STATE OF CONNECTICUT
CONNECTICUT SITING COUNCIL

IN RE:	:	
	:	
A PETITION FOR A DECLARATORY	:	PETITION NO. 1425
RULING THAT A CERTIFICATE OF	:	
ENVIRONMENTAL COMPATIBILITY AND	:	
PUBLIC NEED IS NOT REQUIRED FOR THE	:	
CONSTRUCTION, OPERATION AND	:	
MAINTENANCE OF A 1.9 MWAC SOLAR	:	
PHOTOVOLTAIC PROJECT AT 360	:	
GAYLORD MOUNTAIN ROAD IN HAMDEN,	:	
CONNECTICUT	:	OCTOBER 20, 2020

RESPONSES OF GAYLORD MOUNTAIN SOLAR PROJECT 2019, LLC
TO CONNECTICUT SITING COUNCIL INTERROGATORIES, SET ONE

5 **FARM FENCE & GATE DETAIL**
SCALE : N.T.S.

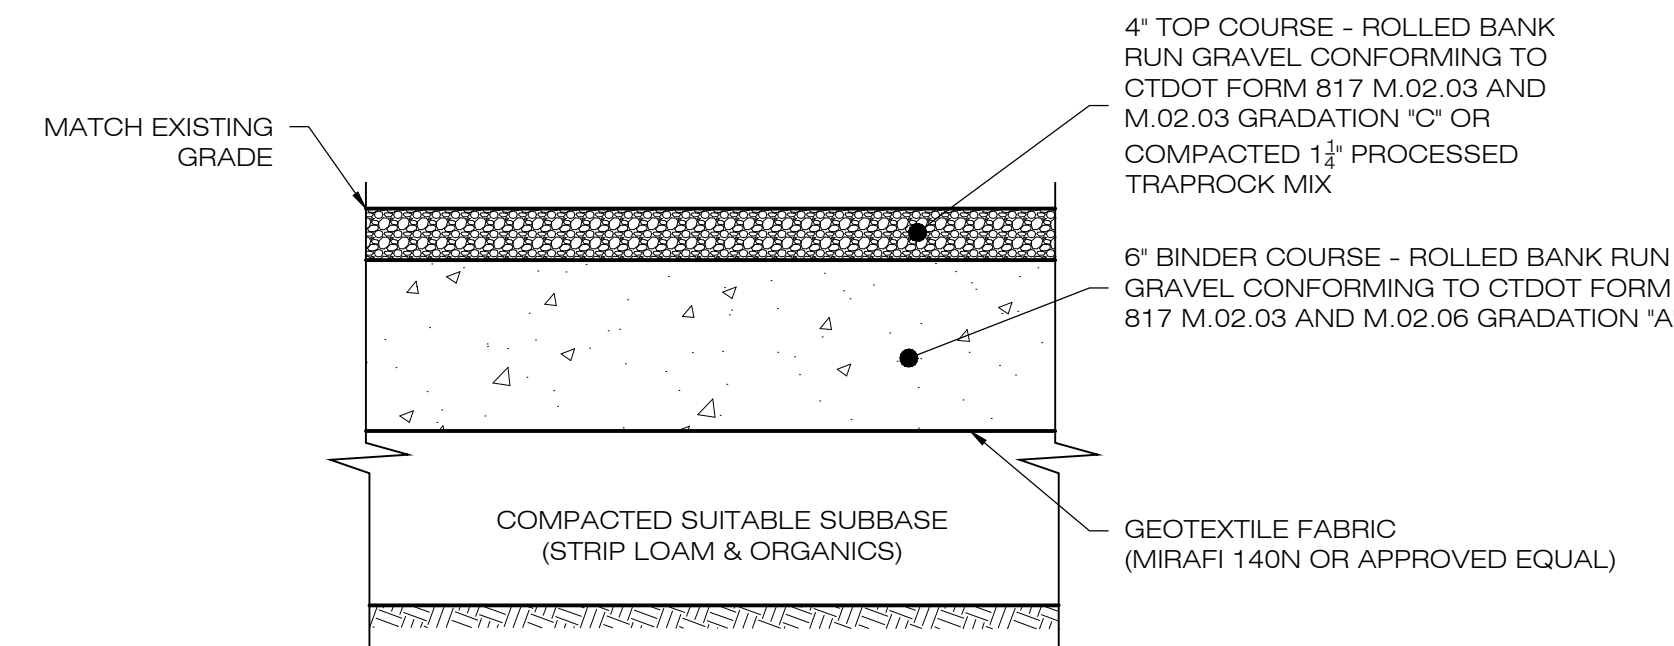
Petition p. 4 states a 6-foot tall farm fence with 4-6 inch opening at base of fence for wildlife movement, however, the space at the base of the fence is not shown on Exhibit H Site Plan DN-1. Provide revised Site Plan DN-1.

Would the Petitioner consider a 7-foot high farm fence consistent with Section 691.4(2) of the National Electrical Code (NEC), 2020 Edition notes that, “Access to PV electric supply stations shall be restricted by fencing or other adequate means in accordance with 110.31...” Section 110.31 notes that for over 1,000 Volts, “...a wall, screen, or fence shall be used...A fence shall not be less than 7 feet in height or a combination of 6 feet or more of fence fabric and a 1 foot or more...utilizing barbed wire or equivalent.”

The proposed Farm Fence & Gate Detail (Detail 5/DN-1) on sheet DN-1 of the Site Plan (Petition – Exhibit H) has been updated to reflect the proposed 4-6 inch opening at the base of the fence for wildlife movement. *See* revised plan sheet DN-1 included as Attachment 3.

The Petitioner would agree to install a 7-foot high farm fence. The proposed Farm Fence & Gate Detail (Detail 5/DN-1) on sheet DN-1 of the Site Plan (Exhibit H) has been updated to reflect the 7-foot high fence, which is consistent with Section 694.4(2) of the National Electrical Code (NEC), 2020 Edition. *See* Attachment 3.
